Urgent Field Safety Notice

Software Distribution Network & Associated Programmers

Product Name	Model Number
CareLink™ 2090 Programmer	2090; All Serial Numbers
CareLink Encore™ 29901 Programmer	29901; All Serial Numbers

October 2018

Appendix A Programmer Software Screen

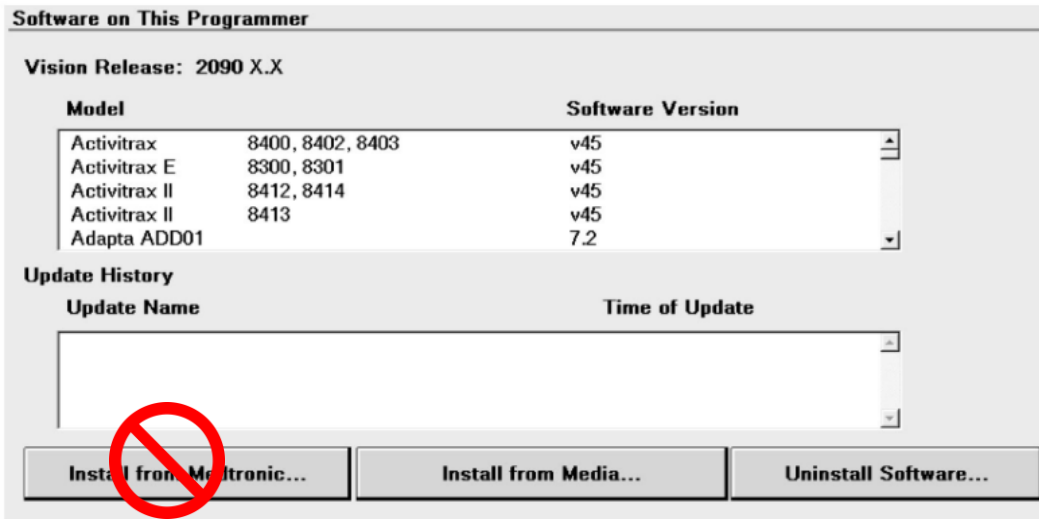
Do not attempt to update the programmer via the SDN. If you select the "Install from Medtronic" button, it will result in an unsuccessful installation of software because access to the external SDN is no longer available.

Several messages may be observed if installation of software from the SDN is attempted (e.g. "Install from Medtronic..."). See images below for example as to what will appear on the programmer display during the installation attempt. Below the larger "Please Wait" message will be a smaller window with a <connection status message> displayed; refer to highlighted area below. The connection status messages may alternate *between* "Connecting...", "Searching for Network...", "Logging in...", "Unable to connect to local network", and "Unable to connect to Medtronic". Since the SDN is no longer available, **the user should select "Cancel" to terminate the installation attempt.**

If the user cycles power on the programmer without first cancelling the installation attempt, upon power-up a count-down window will appear on the screen for approximately 30 seconds with "Yes" and "No" buttons. The user should select "No" to terminate the installation attempt and return to the Model Select screen. If the user selects "Yes" or does not respond prior to the 30-second time out, the programmer will attempt the installation again, and the process described above will repeat until the user either selects "Cancel" or selects "No" during the count-down window.
